# Staff Report

## Site Plan Review

### Second Floor Apartment Conversion

SP-19-18

1 SITE PLAN  
1" = 20'-0"

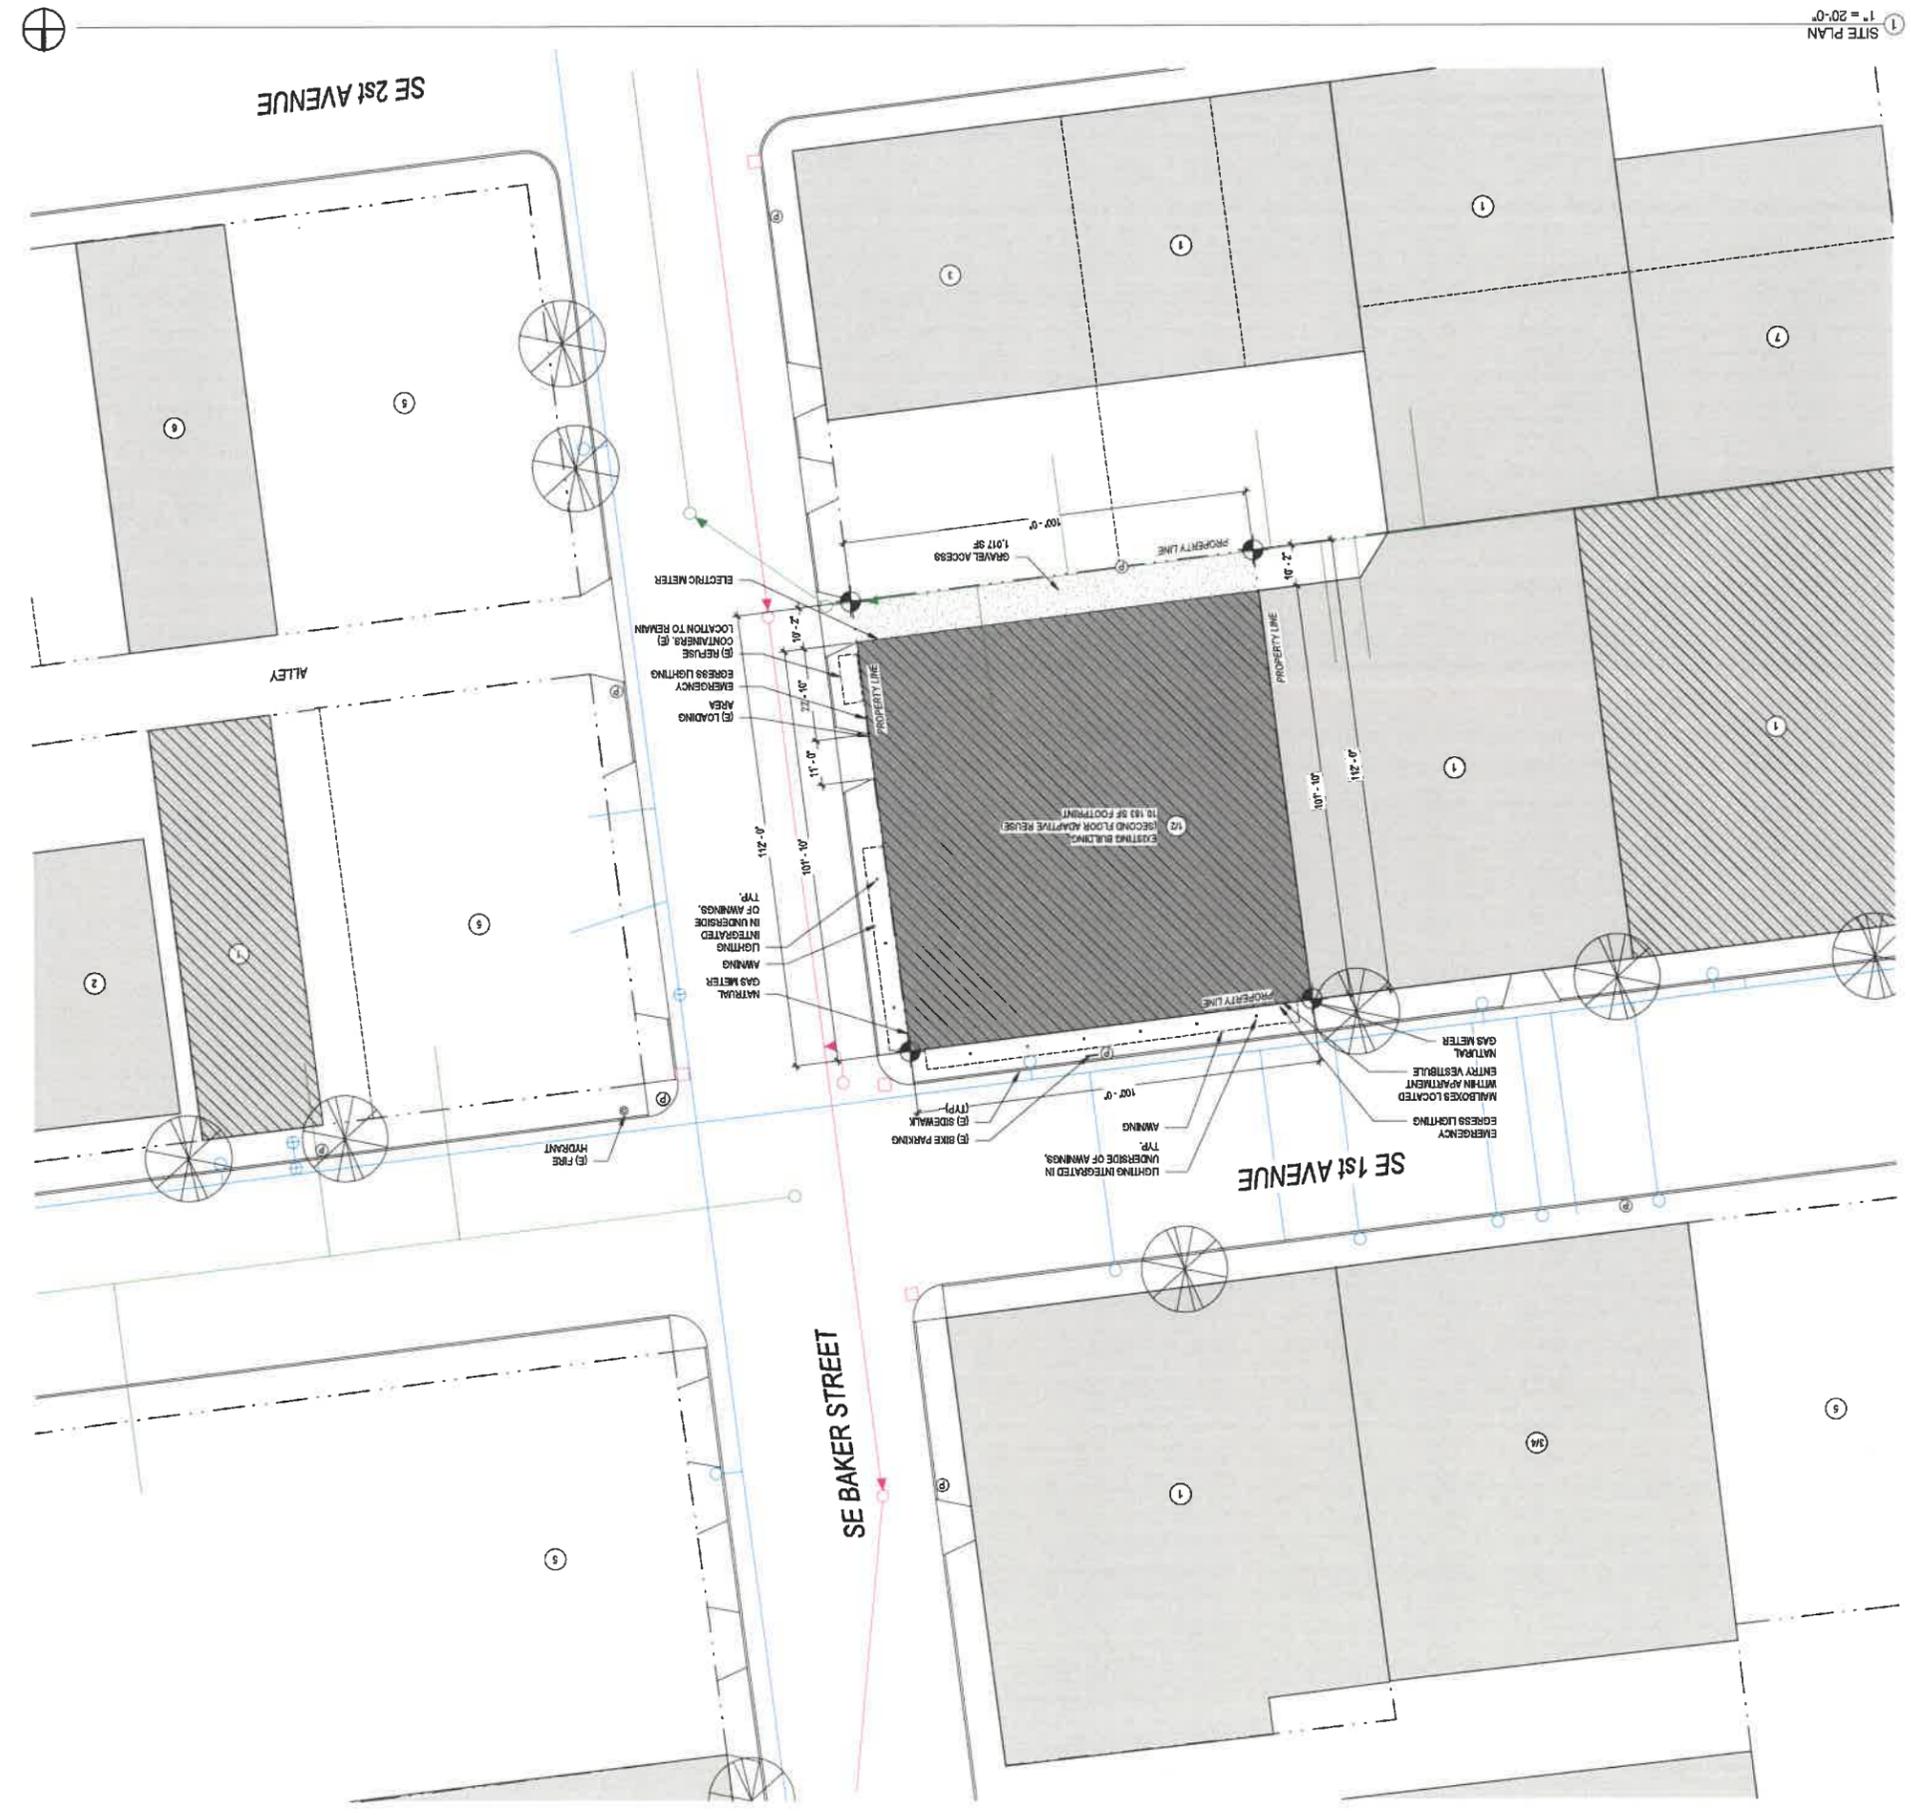
- 5.8 Screening of Refuse Containers: ADC 5.370 requires refuse container areas to be screened from public view. The site plan shows an unscreened refuse container in the public right-of-way (Attachment B.2). Refuse containers are not permitted in the public right-of-way. Screening of refuse containers on the subject property will be included as a condition of approval.

Condition 1 Prior to issuance of a certificate of occupancy, the applicant shall submit a revised site plan for review and approval to the Community Development Department that includes screening of refuse containers by the placement of a sight-obscuring fence, wall, or hedge at least six feet tall, in accordance with ADC 5.370.

Condition 2 Prior to issuance of a certificate of occupancy, all required screening for refuse containers or disposal areas shall be installed in accordance with ADC 5.370.
